Access Compliance Report

Public Rights-of-Way

Intersection ID: 14251	Main Street: CHESTERFIELD_AV	Cross Street: LORNA_ST	Location: E
ADA ID: 2B32AAA5F576	Ramp Type: Perp	Initial Pass/Fail: Fail	Overall Compliance: No
		Severity Score: 12.5

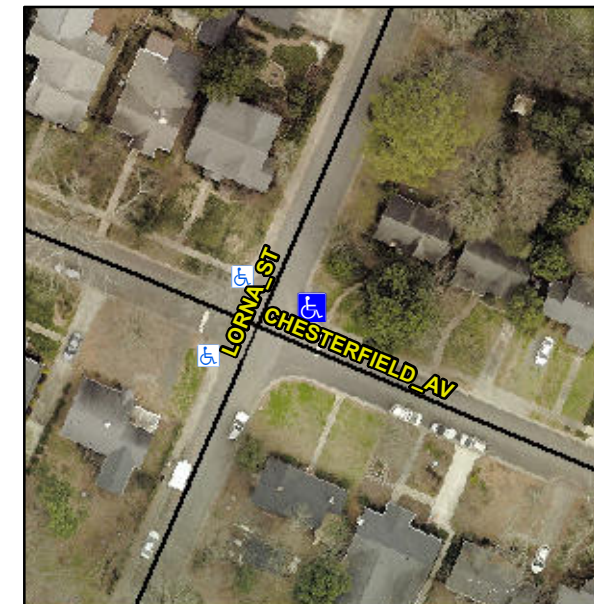
R304.5.3

Compliance	Description	Data	Compliance	Description	Data
N/A	Ramp Length (in)	56.0	Yes	Ramp Slope (%)	5.2
Yes	Ramp Width (in)	62.0	No	Ramp XSlope (%)	6.2
N/A	Flare Type LT	N/A	N/A	Flare Type RT	N/A
N/A	Flare Slope LT (%)	N/A	N/A	Flare Slope RT (%)	N/A
N/A	Flare Traversable LT?	N/A	N/A	Flare Traversable RT?	N/A
N/A	Landing Length (in)	N/A	N/A	DWS Provided?	N/A
N/A	Landing Width (in)	N/A	N/A	DWS Contrast?	N/A
N/A	Landing Slope (%)	N/A	N/A	DWS Length (in)	N/A
N/A	Landing X Slope (%)	N/A	N/A	DWS Full Width?	N/A
N/A	Landing Curb? (Y/N)	N/A	N/A	DWS Offset (in)	N/A
N/A	Shared Landing?	N/A			
N/A	Gutter Ponding?	N/A	N/A	Gutter Slope (%)	N/A
N/A	Gutter Lip Ht (in)	0.5	N/A	Gutter X Slope (%)	N/A
N/A	Painted X Walk1?	No	N/A	Painted X Walk2?	N/A
	X Walk 1 Direction	To NW		X Walk 2 Direction	N/A
N/A	X Walk 1 Width (in)	N/A	N/A	X Walk 2 Width (in)	N/A
	X Walk 1 Slope (%)	11.3		X Walk 2 Slope (%)	N/A
	X Walk 1 X Slope (%)	0.3		X Walk 2 X Slope (%)	N/A

Remove & Replace Entire Ramp.
